REMARKS

A first Office Action was mailed on July 13, 2004. Claims 1 – 14 are pending in the present application. With this Response, Applicants propose revisions to FIGs. 4, 14a, 14b, 15 and 16, amend the specification, cancel claim 8 without prejudice or disclaimer, and amend claims 1 and 11 to substantially include the limitations of canceled claim 8. No new matter is introduced. Support for the claim amendments may be found, for example, in Applicants' specification at page 8, line 50 to page 9, line 21, and at page 13, lines 12 to 26.

Fig.4

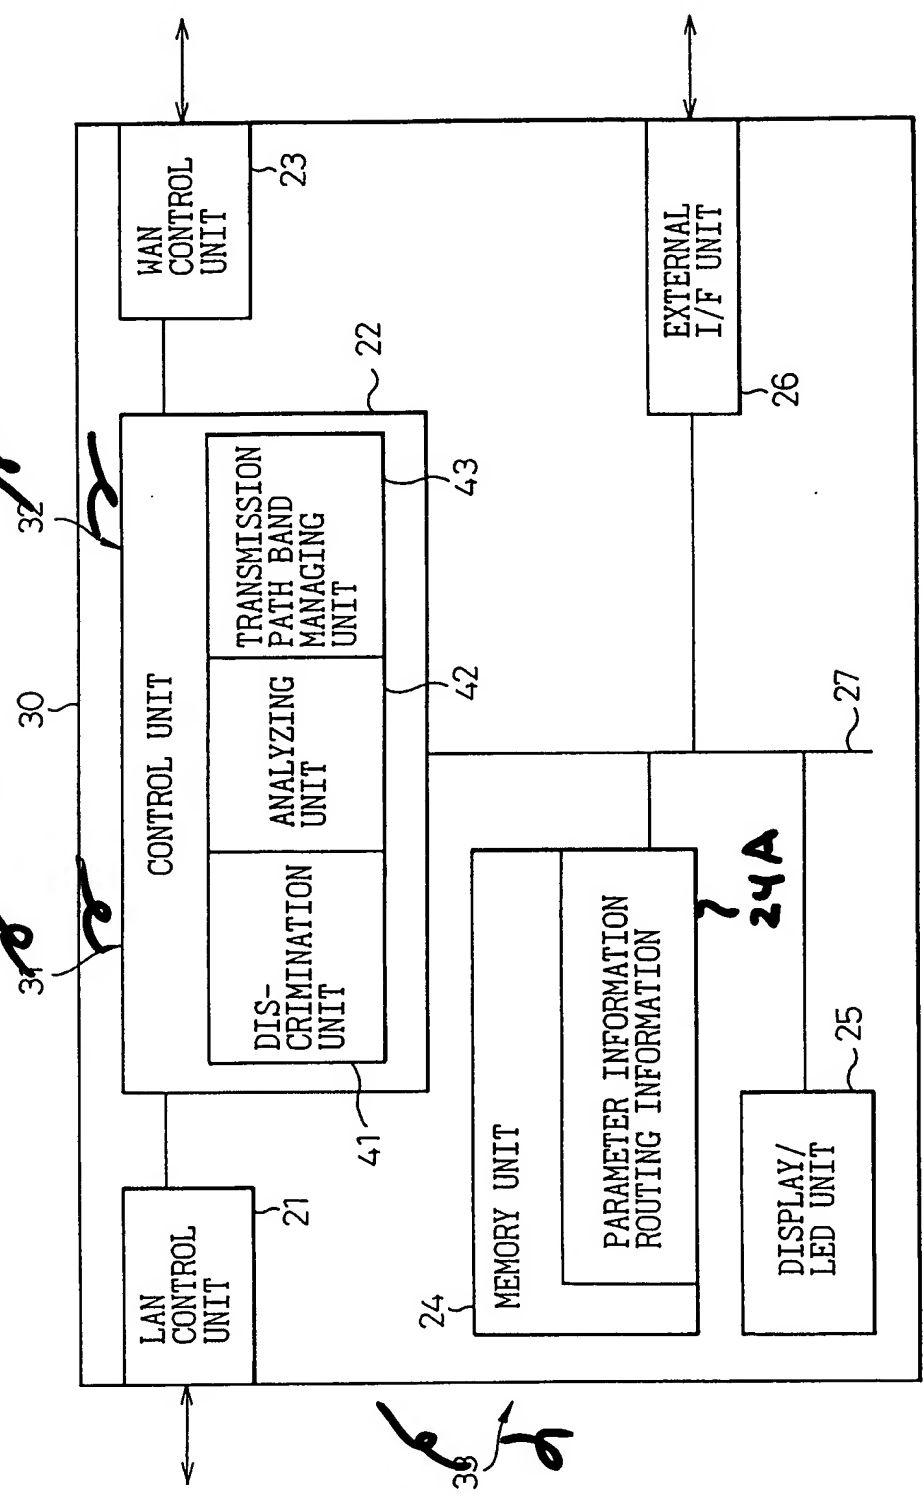
FIG. 4 is objected to as including multiple reference numerals for an individual object (e.g., numerals 31 and 32 and 22, and numerals 30 and 33). Several of these reference numerals were introduced with reference to FIG. 2. Applicant proposes revisions to FIG. 4 to eliminate the redundant reference numerals introduced with FIG. 2, and amends the specification in accordance with these proposed changes

These proposed revisions to FIGs. 4, 14a, 14b, 15 and 16 are indicated in the attached drawing replacement sheets, provided in both marked-up and clean copies. Applicants respectfully request that the proposed revisions be accepted, and that the objection be withdrawn.

Fig.14a

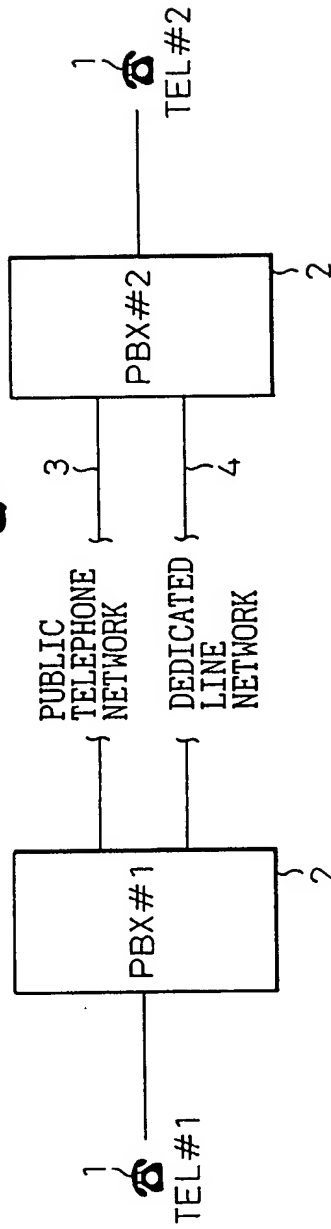
FIGs. 14a, 14b, 15 and 16 are objected for failing to be designated as “Prior Art”. Applicant proposes revisions to FIGs. 14a, 14b, 15 and 16 to designate each of these figures as “Prior Art”.

PRIOR ART
